ADDENDUM NO. 3

**REQUEST FOR TENDERS #: T-683-24
REPLACEMENT OF ROOF AT WOODLANDS OPERATION CENTRE, 1179 BRONTE ROAD,
OAKVILLE, ON L6M 3L1**

This Addendum No. 3, issued Monday, May 6, 2024, must be incorporated into and made part of the above noted Request for Tenders Document.

1 ROOF KEY PLAN
A1 SCALE: 1:200

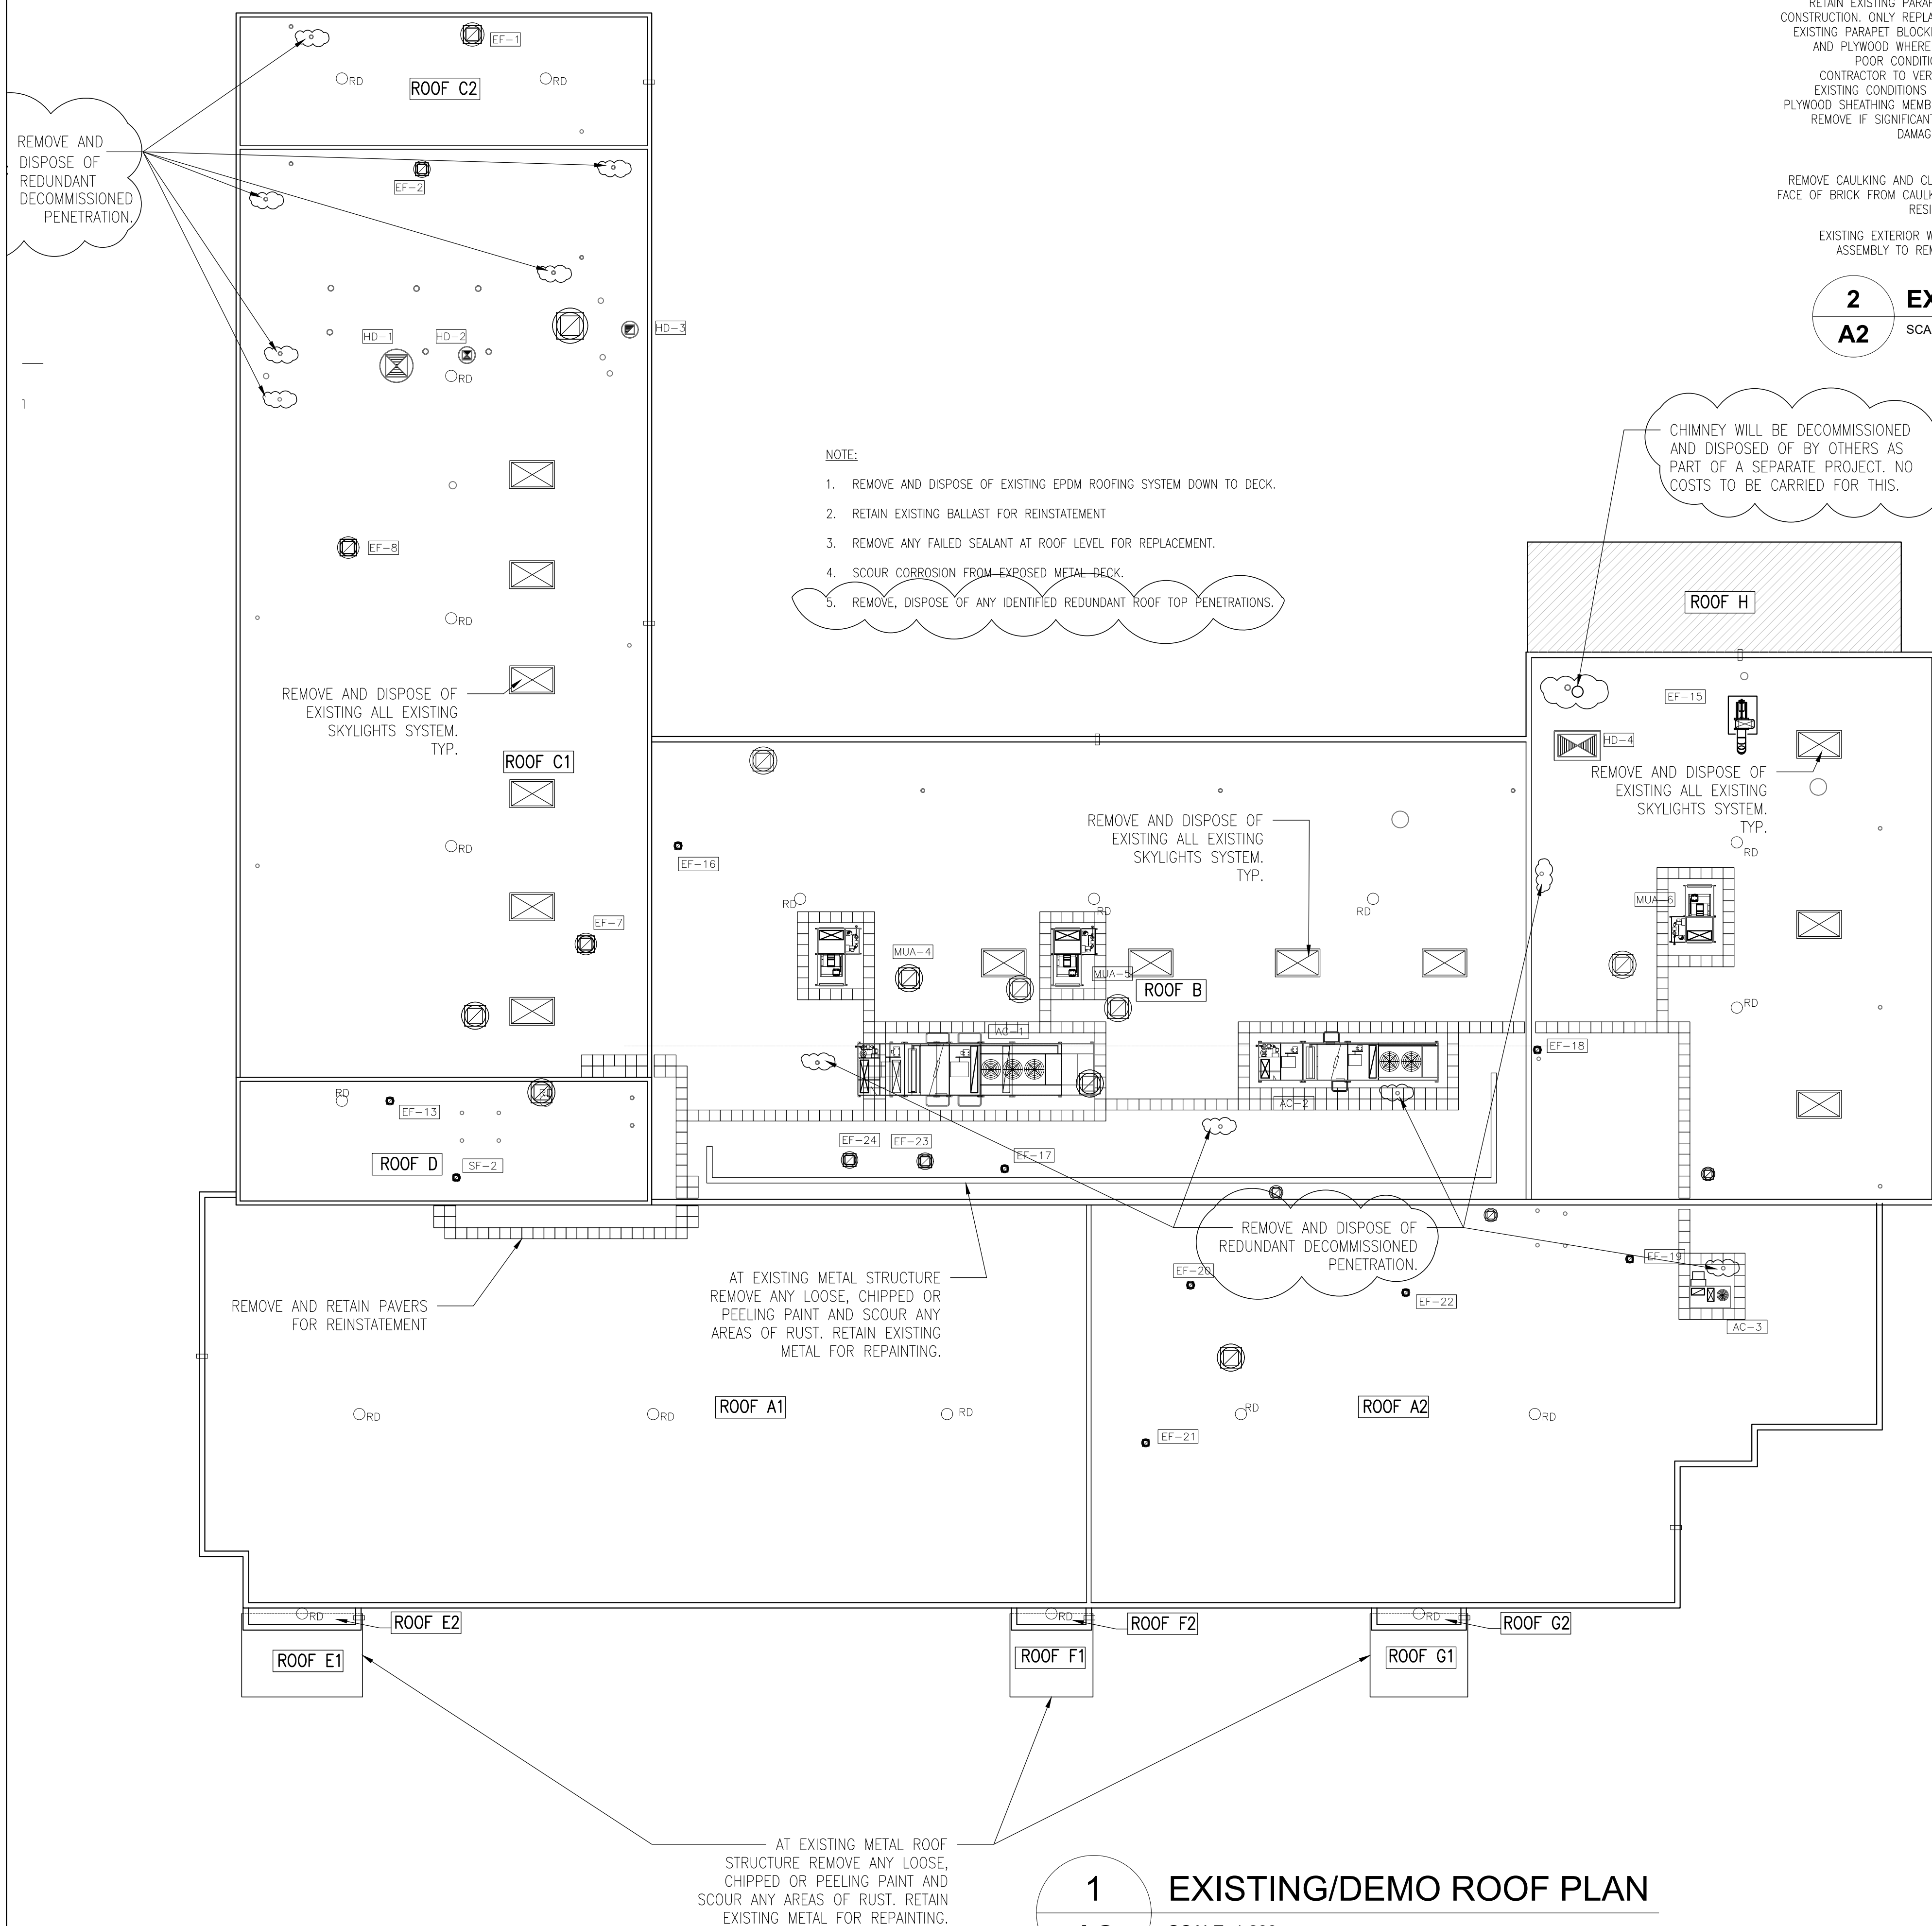
Question 7: what is the estimated length and type of carpentry to be replaced at parapet?

Question 9: in the tender form Mod. Bit. Roof has two groups E1, F1, G1 & E2, F2, G2 not shown on drawings.

The dimensions provided on Drawing 1/A1 (Roof Key Plan) could be used to give a rough calculation of the perimeter however, as stated, these dimensions have not been site verified.

Answer 9: The distinction is outlined in Section 01 11 00 - Summary of Work of Attachment 1 – Technical Specifications. E1, F1, G1 are the upper overhang roofs and E2, F2, G2 are the roofs which site below these. Updates have been made for clarification in the attached revised drawings.

2
A2 EXISTING/DEMO ROOFING DETAIL (TYP.)
SCALE: 1:8

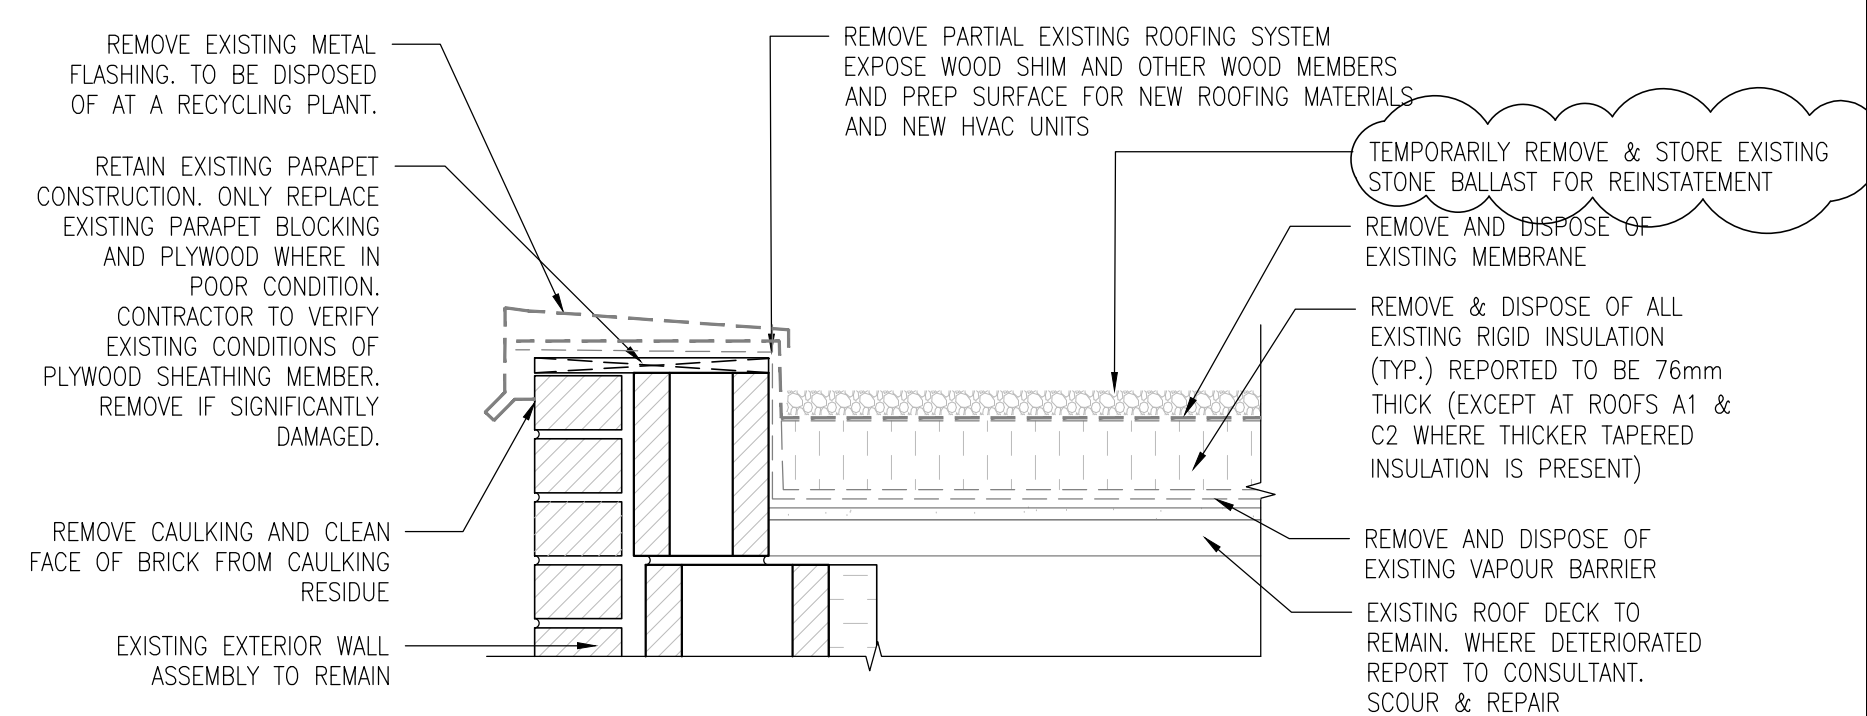
Question 16: Drawing detail 2/A2 (Existing/Demo Roofing Detail (TYP.)) states remove and dispose existing Ballast. However, Note 2 says retain existing ballast for reinstatement. Please clarify.

Answer 16: Existing Ballast is to be stored and reinstated. Drawing detail 2/A2 has been corrected in the revised drawings attached hereto.

1
A2 EXISTING/DEMO ROOF PLAN
SCALE: 1:200

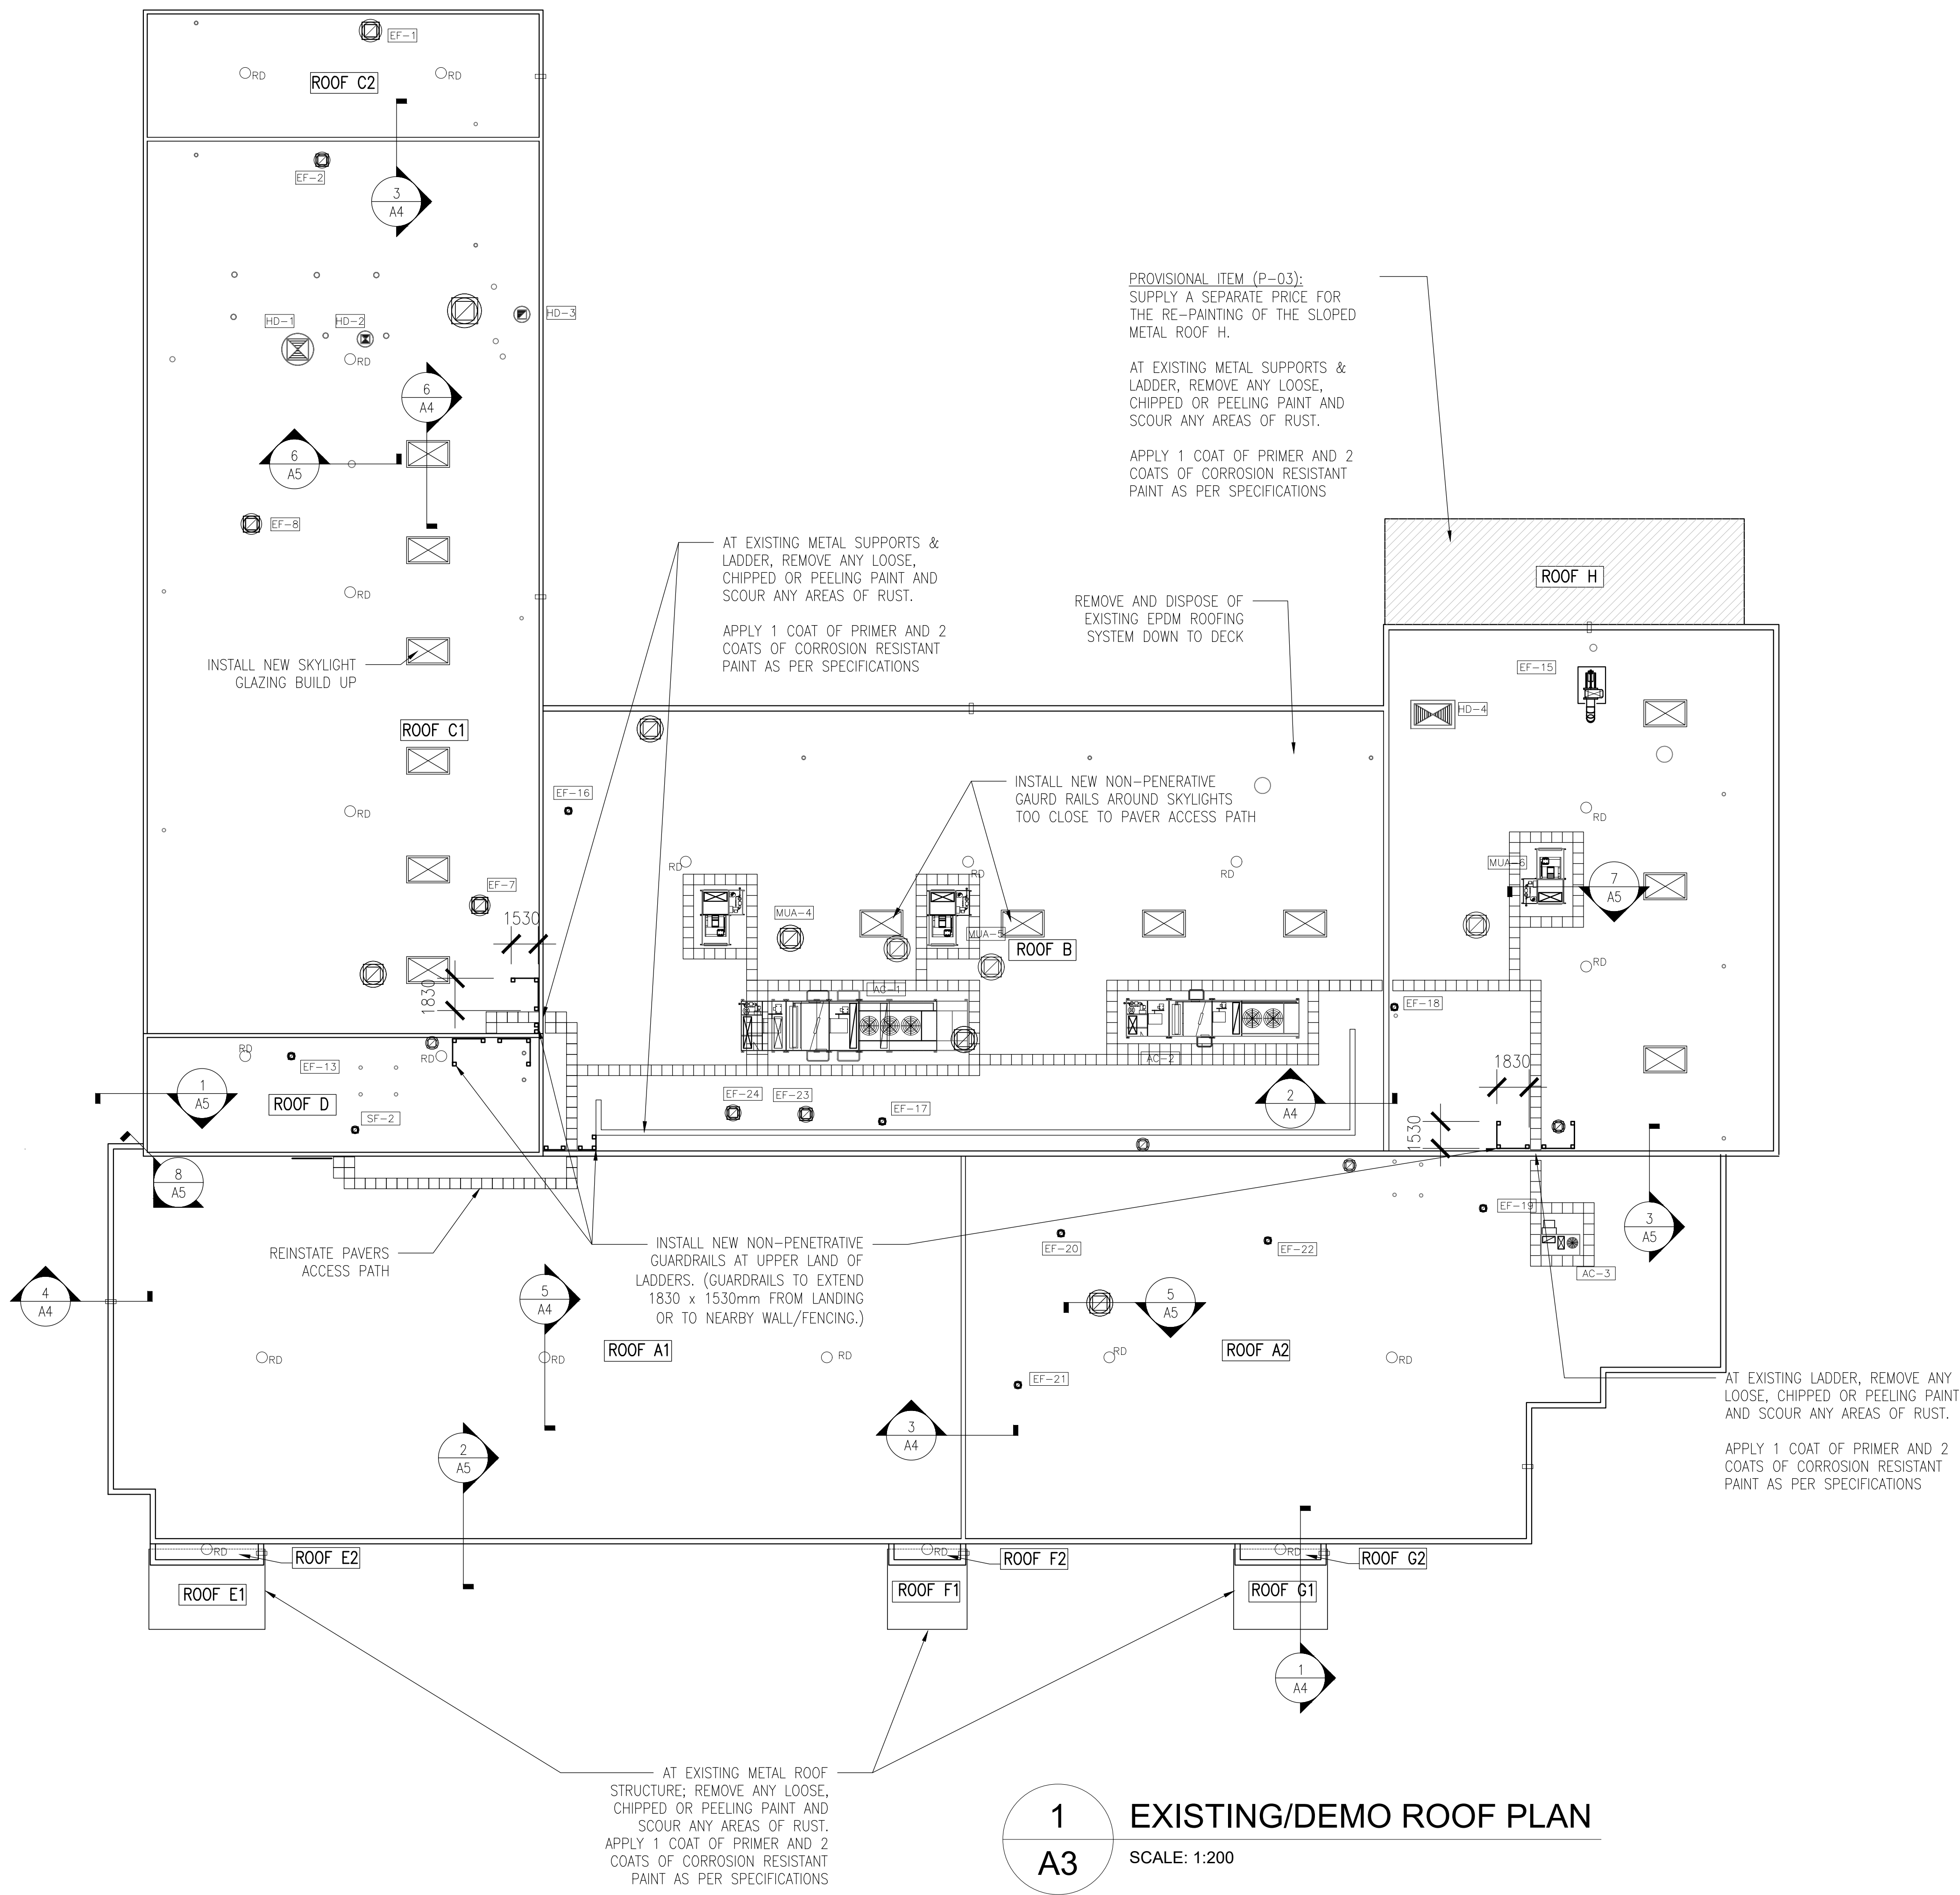
Question 17: Note 5 of Drawing Detail 1/A2 has no text, can this be clarified?

Question 18: Is the Chimney at Roof B still in service?

Answer 17: Note 5 has been corrected to state "REMOVE, DISPOSE OF ANY IDENTIFIED REDUNDANT ROOF TOP PENETRATIONS". Refer to the revised Drawing A2 attached hereto.

Answer 18: This chimney is being decommissioned as part of a separate project. No costs are to be carried for this work. The winning bidder will co-ordinate with the other contractor for scheduling. See note on revised Drawing A2.

2 STRUCTURAL SUPPORT DETAIL
A4 SCALE: 1:8

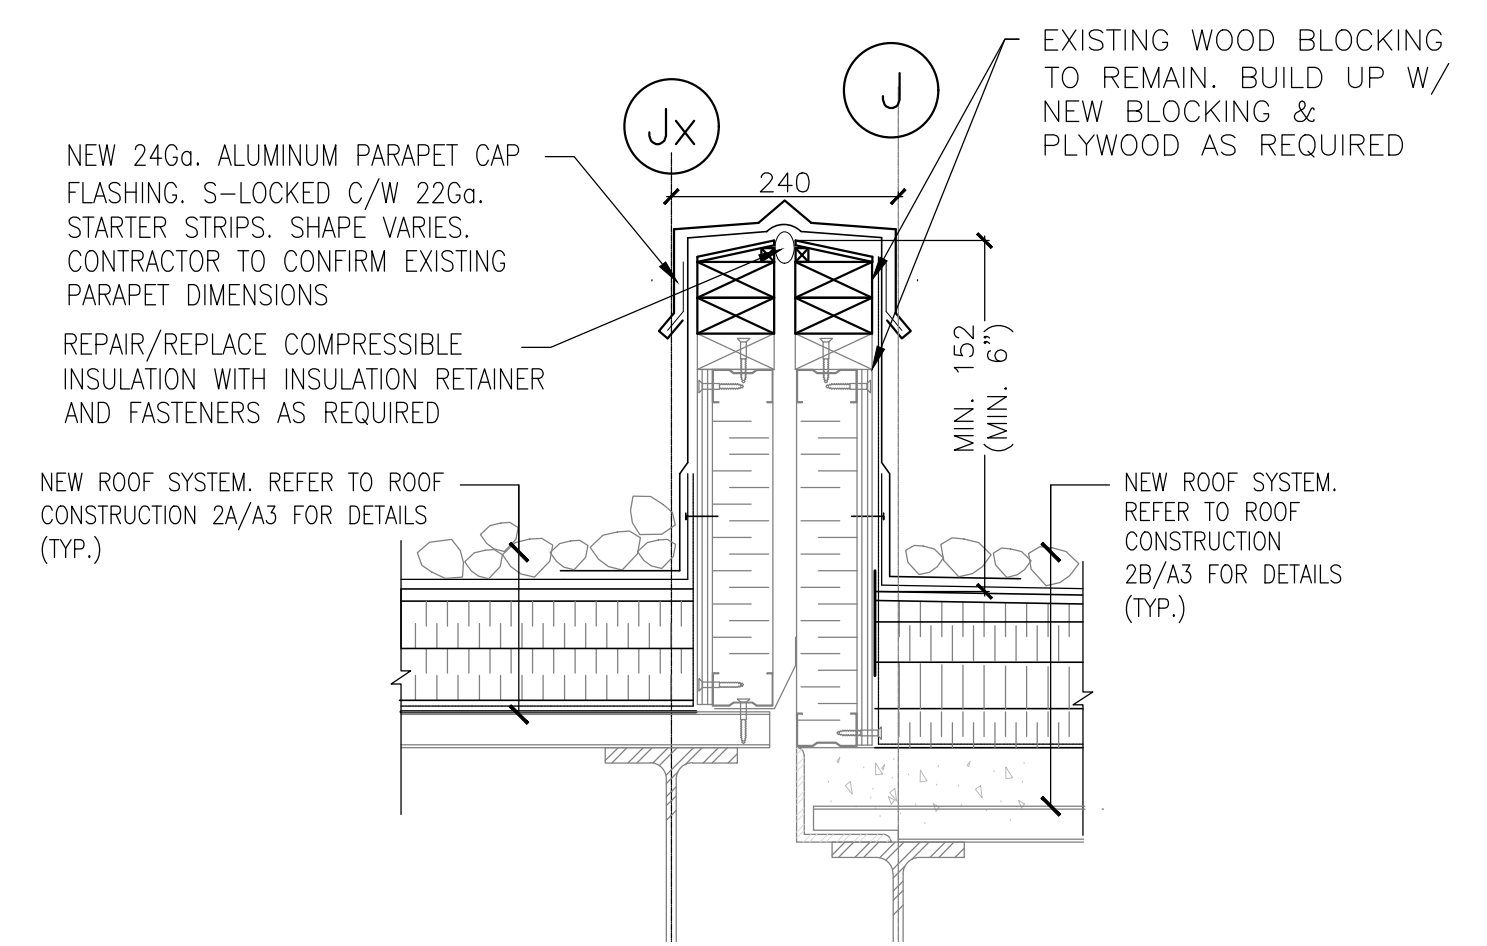
Question 19: Does the metal siding have to be repainted or only the structural supports?

Answer 19: As per Drawing detail 2/A4 only the metal structure requires full repainting. At the ladders and horizontal siding only (the minimal) localized areas of corrosion are required to be repainted.
